Beaver Valley 1

Technical Evaluation Report
on the Individual Plant Examination
Front End Analysis

NRC-04-91-066, Task 31

Prepared for the
Nuclear Regulatory Commission

Figure 2-1. CDF by Initiating Event

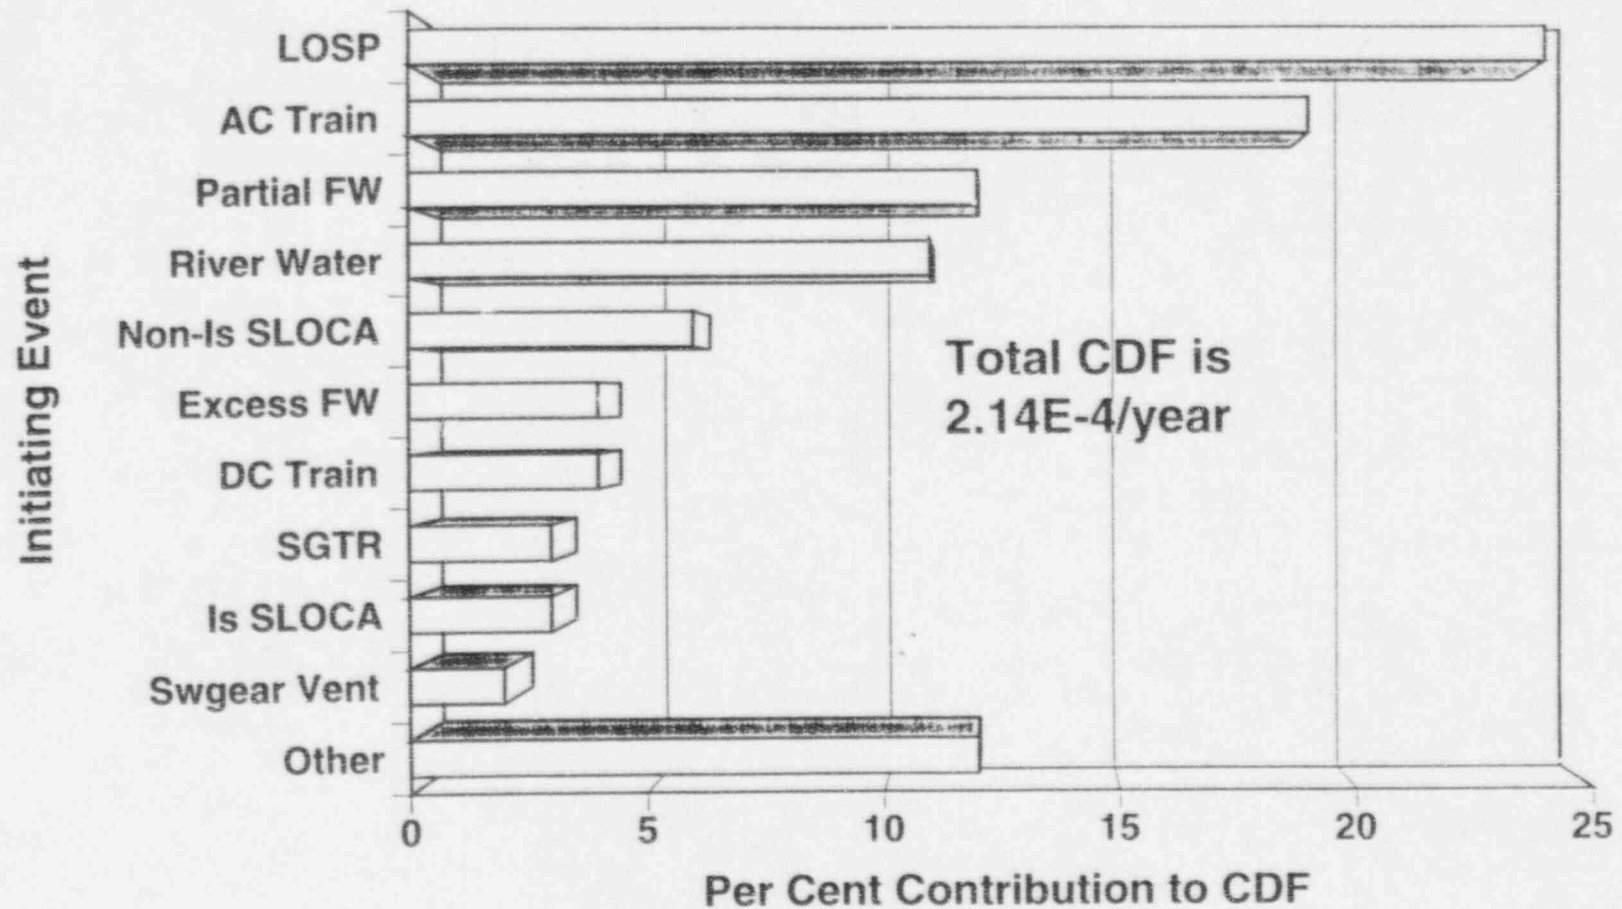
Excessive feedwater is predicted to contribute almost 4% to overall CDF, as indicated in Figure 2-1 of this report. Based on a review of the dominant sequences, this is due to ATWS following this initiating event. [IPE submittal, Table 3.4.1-1 Sequence # 25] The mean frequency for excessive feedwater is 0.235, which is high, and the event results in loss of feedwater. [IPE submittal, Tables 3.3.1-4 and 3.1.1-2] The high probability of failure to provide insufficient pressure relief for an ATWS with loss of main feedwater leads to core damage.

Figure 2-2. CDF by Accident Category

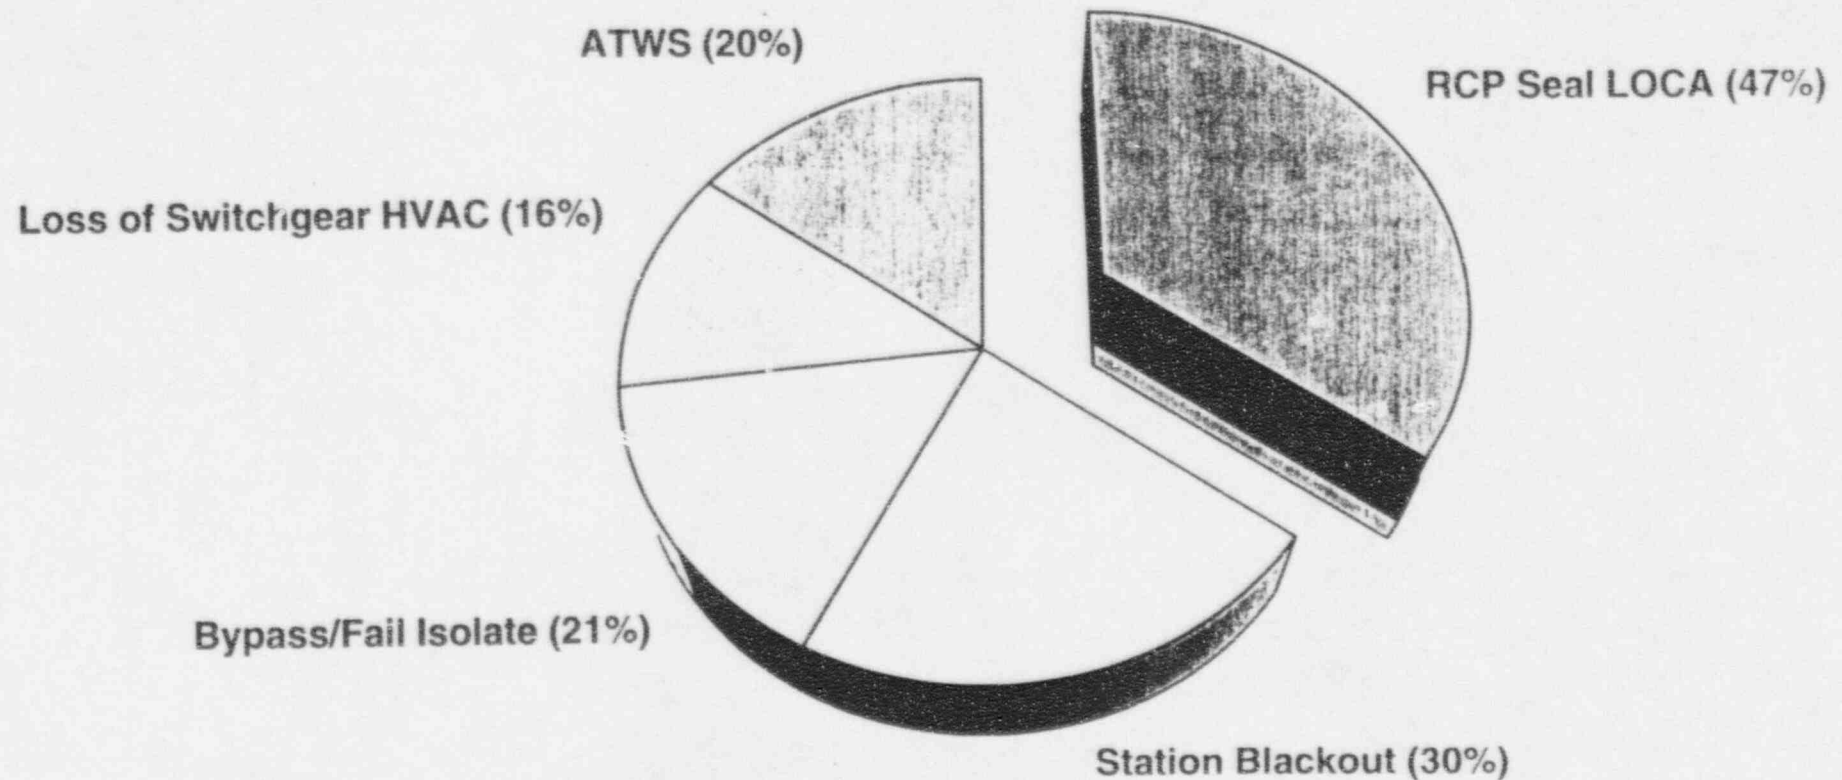
As indicated in Figure 2-2 of this report, ATWS is a relatively high contributor to the overall CDF at Beaver Valley 1, more so than at most PWRs. The high contribution of ATWS is due to failure to provide adequate pressure relief. [IPE submittal, Page 3.4-

41] As noted previously in this report, the plant operates with two of the three pressurizer PORV block valves closed. The licensee has reevaluated ATWS and concluded that the contribution of ATWS to the total CDF is significantly less than reported in the submittal; this is discussed in Section 2.7.3 of this report.
